REMARKS

Drawing Objections

Amendments to the Drawings

FIG. 2A

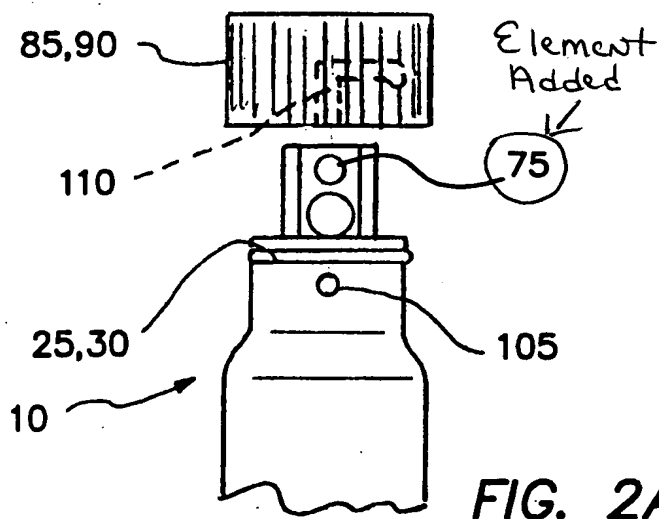
The Examining Attorney has objected to the drawings under 37 CFR 1.83(a), stating that the drawings must show every feature of the invention specified in the claims. “Therefore, the loops and hook (of claims 3,4,27,28), spring "outside" (claims 6,30), "containers" (claim 51, line 2) the container must be shown or the feature(s) canceled from the claim(s). No new matter should be entered.”

On p. 25, how does container 10 "enclose" (line 13) the platform 195? After all, the container does not contain that element 195. Isn't the lead line for 195 (in Figure 9) incorrect? Where is element 195 in Figure 9?

Applicant has amended **Figure 2A** and added new **Figures 2B** and **2C**, illustrating the loops and hooks claimed. Please see attached “Replacement Sheets and Annotated Sheets Showing Changes.” The issues relating to the spring “outside” and container have been addressed in the Amendment to the Drawings Section above.

“(38) In another variant, as illustrated in **Figures 9-11**, the sampling container **10** is sized and shaped to substantially enclose the support platform **195** within outer horizontal dimensions **295** of the sample container **10**.” (Page 25, lines 12-14) As stated above, the container **10** encloses the support platform **195** to the extent that the support platform **195** fits within outer horizontal dimensions **295** of the sample container **10**. The idea here is that the sampling device **190** which includes the support platform **195** and the container **10** can be used in a pipe or conduit no larger than the outer horizontal diameter or dimensions of the container **10**. The lead line for element **195** is incorrect, it should extend to the platform and not stop at the container body **20**. Please see Amendments to the Drawings on page 18, *supra*.

The attached Replacement Sheet of drawings includes changes to **Figure 2A**. The new drawing sheet includes **Figures 2B** and **2C**. The Replacement Sheet, which includes **Figures 1, 2, and 2A**, replaces the original sheet which included **Figures 1, 2, and 2A**. In **Figure 2A**, previously omitted element **75** has been added. Element **75** was previously shown in **Figures 1, 2, 4** and **11**. In new **Figures 2B** and **2C**, previously described but unlabeled elements **77** and **79** have been added. Support for these changes is found in Claims 3, 4, 27 and 28 and on page 20, lines 2 and 5 and on page 24, lines 4 and 6 (see Amendments to the Specification above). No new matter has been added.
